Subject: Pre-Application Summary Notes for Vineyard Phase II Townhomes (PA2023-00468)

PRE-APPLICATION CONFERENCE MEETING SUMMARY NOTES

Prepared for Vineyard Phase II Townhomes PA2023-00468

ZONING PLAN

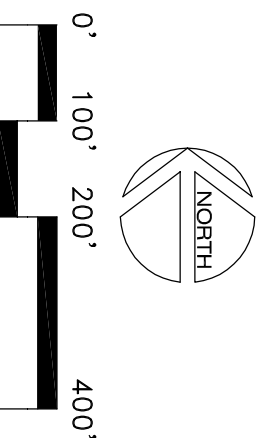
3. **ZONING:** The applicant's pre-application form states that the site is zoned R4. The site appears to be a combination of R2 and R4 zoning according to the proposed zoning map attached.
